## 03 Independent Quality Assurance: Pre-plaster Inspection

03 Independent Quality Assurance: Pre-plaster Inspection

Double storey  
Slab on ground  
Timber frame  
Sheet roof  
Brick Veneer  
Rendered lightweight cladding

Photo 10

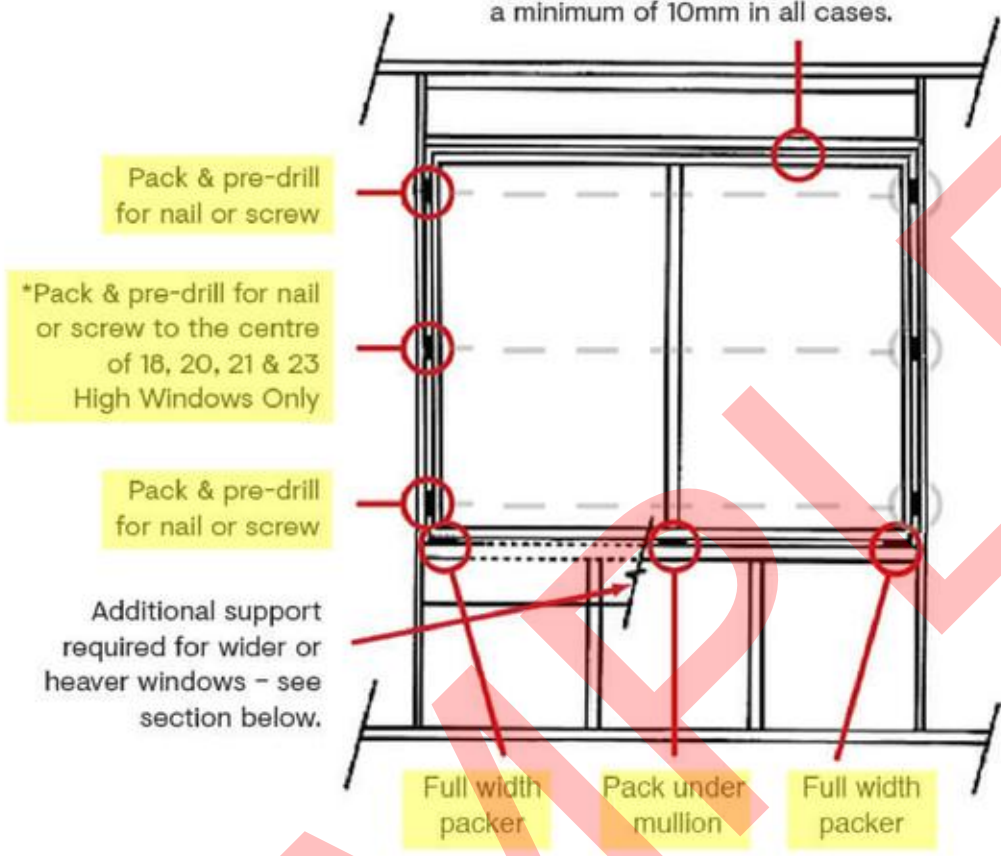
DEFECT

1. Windows not packed under structural members.
2. Windows not packed at fixing locations.

A&L installation guidelines specify fixing and packing requirements as per the below:

Timber framing standards require minimum 15mm gap at head for settlement, we recommend 20mm, not packed. Other frame types may require less, but we recommend a minimum of 10mm in all cases.

Photo 58

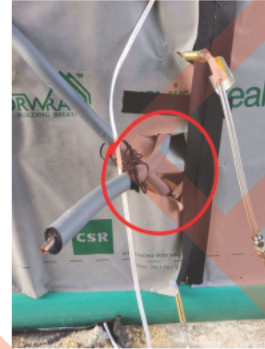
DEFECT

Refer to Australian Standards AS 4200.2, Pliable building membranes and underlays sections 4.3 VAPOUR CONTROL AND AIR CONTROL and 4.4 WATER CONTROL respectively:

"Where a pliable building membrane is installed as a water control membrane, penetrations shall be sealed with a pressure-sensitive and heat- and moisture-resistant tape.

Photo 63

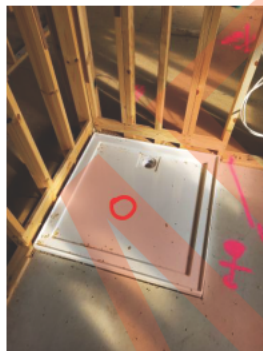
DEFECT

Shower base chipped / damaged.

Refer to the VBA's Guide to Standards and Tolerances section 10.06 Manufactured material: "Any cracking, displacement, pitting or similar blemishes in surfaces of manufactured materials are defective if they are caused by the builder and can be seen from a normal viewing position."
